IN THE UNITED STATES PATENT AND TRADEMARK OFFICE

In re Application of: Jerry Jenks	)	Date: September 8, 2002
	)	
Serial N°: 09/833,978	)	Group Art Unit: 2833
	)	
Filed: 04/12/2001	)	Examiner: Luebke, R.S.
	)	
For: Electrical Interrupt Switch	)	
	)

Request for Correction to the Drawings Under 37 CFR § 1.123

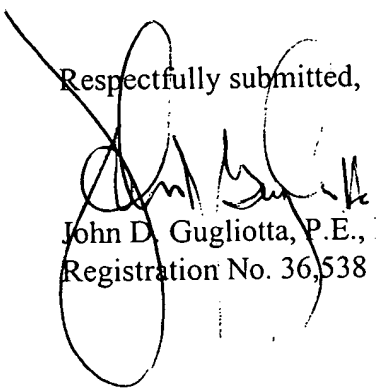
As requested and shown, please delete reference numeral "42" as indicated, while adding cross-hatching to reference numeral "18".

As requested and shown, please delete the original Figure 3, and replace with the newly drawn Figure 3, wherein the first electrical conductive contact 46 has been lengthened and the second electrical conductive contact 48 has been shortened, as originally envisioned but inadvertently reversed in drafting. The corresponding lengthening and shortening of 46 and 48, respectively, correctly illustrates the communicative relationship between the contacts, wherein as the switch is manipulated to complete an electrical circuit, the first electrical conductive contact 46 rotates upward and touches against the second electrical conductive contact 48, thereby completing an electrical circuit and allowing electrical current to flow therethrough.
